May 31, 2016

Re: McKinney Urban Village
Request for Modification of Meritorious Exception for Covered Parking Design

ROOF MATERIAL

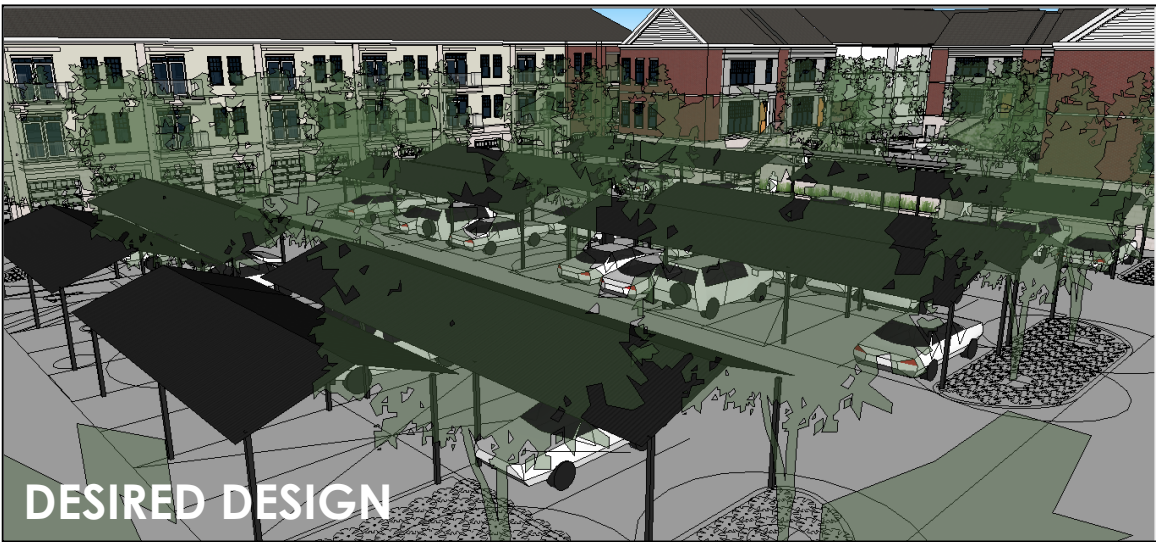
Proposed architectural design concept of car parking cover structures as collection of gabled buildings with a metal structure and roof versus fiberglass. The structures will use the same metal roof as other canopies used on the project (mail canopy, canopy at building entrances, awnings and leasing and club) and blend more appropriately with the architectural design of the buildings.

DESIRED DESIGN

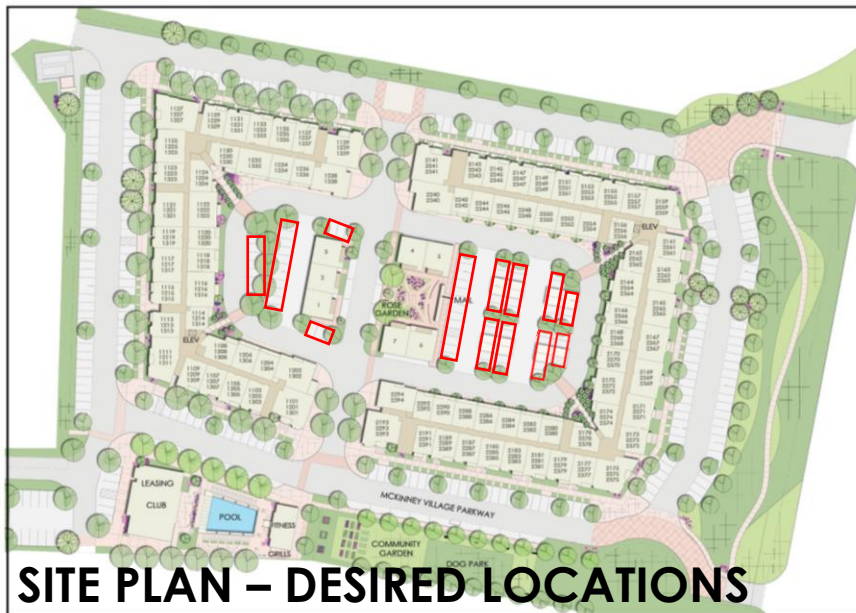
- Car shade covers designed as a gabled structure with 8'-6" minimum clearance, 4:12 sloped roof, and metal columns and roofing versus fiberglass. This design provides a more appealing view for second and third-story residents looking out at a collection of small buildings with a pitched roof versus flat. The metal roof and structure also provides a more durable and weatherproof structure that more adequately shields and protects our residents' vehicles. The metal roof material, used elsewhere on the project, allows us to achieve greater consistency in our design aesthetic.
